# ICHD - ENVIRONMENTAL HEALTH DIVISION

DW Statesville Office (704) 878-5305 | Relocation Mooresville Office (704) 660-3625 | PERMIT # AP 325762

## SEPTIC: IMPROVEMENT PERMIT / AUTHORIZATION TO CONSTRUCT / OPERATION PERMIT / EXISTING SYSTEM

Relocation for Pool

INITIAL SITE SKETCH

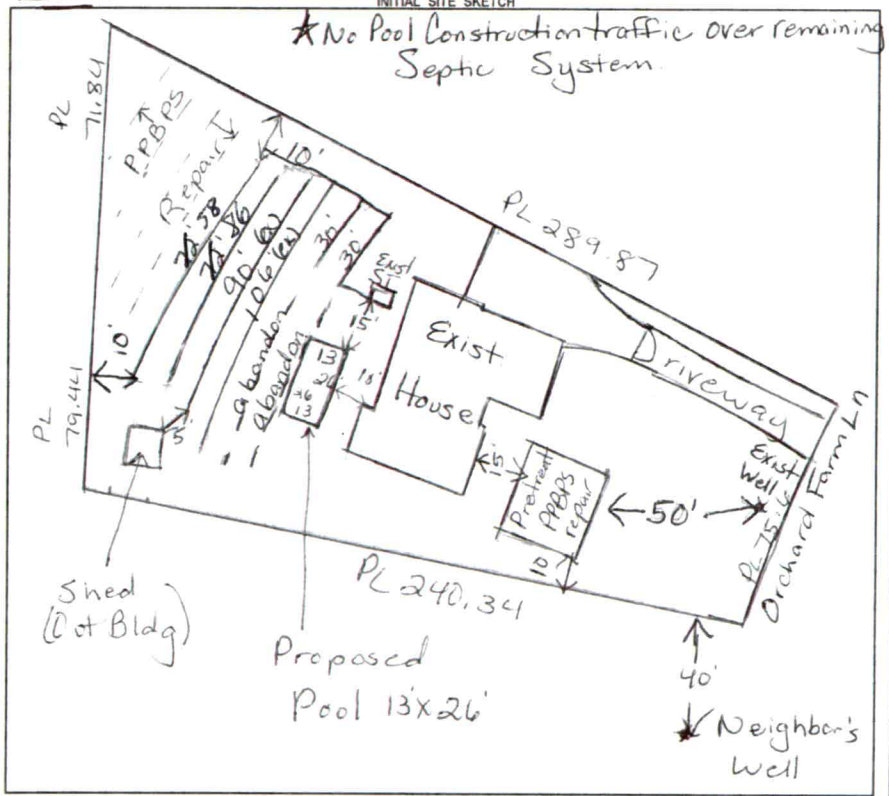
Comments / Conditions: Abandoned Septic Drainfield ∠15ft from pool "cut". Keep first 30ft of upper 2 drainfields abandon rest of drainlines, Add 2 new 72' drainlines

Keep Septic Drainfield at least 5ft from Shed, Pool Equipment water lines must be a minimum of 10ft from Septic.

★Must relocate Septic prior to Pool Construction.

INITIAL SITE SKETCH

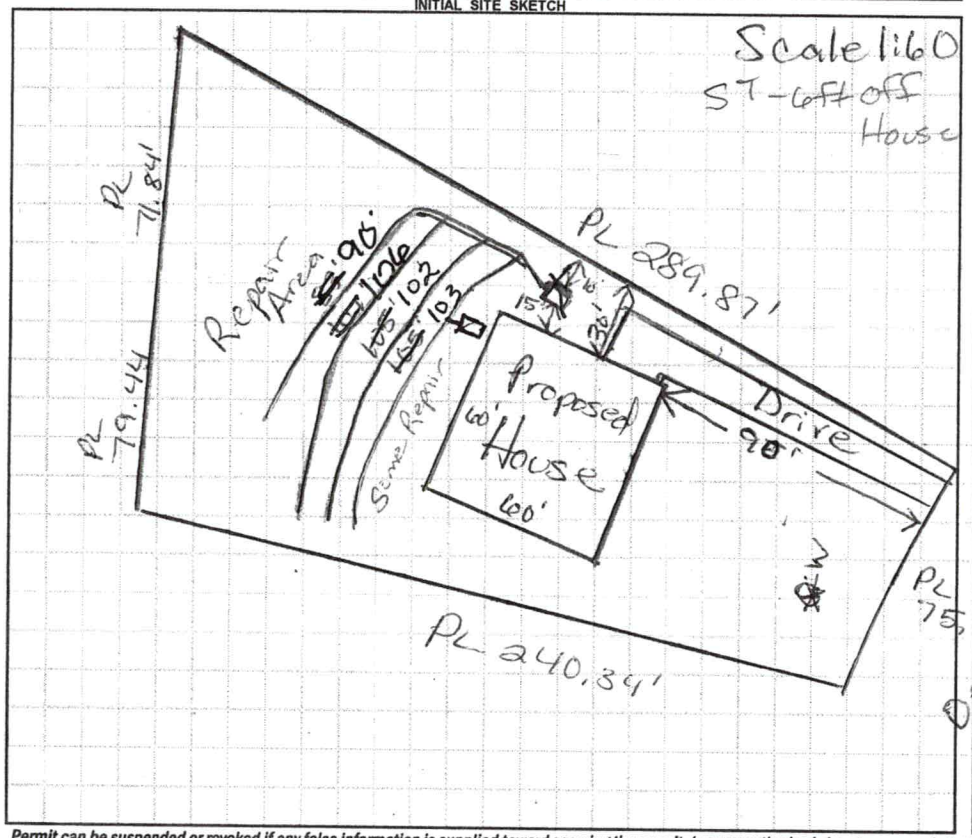
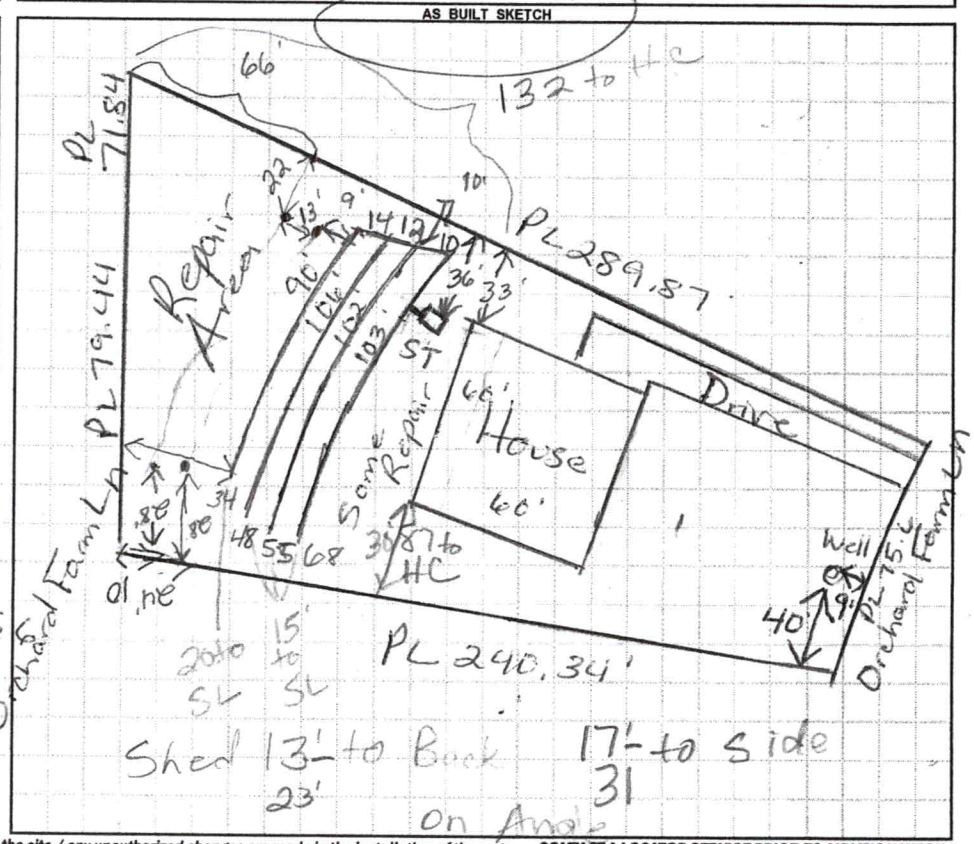
Comments / Conditions: ~~X~~ Do Not Cut down for basement

5/9/17 Checked ST & Upper 2 lines
5/16/17 Checked last 2 lines
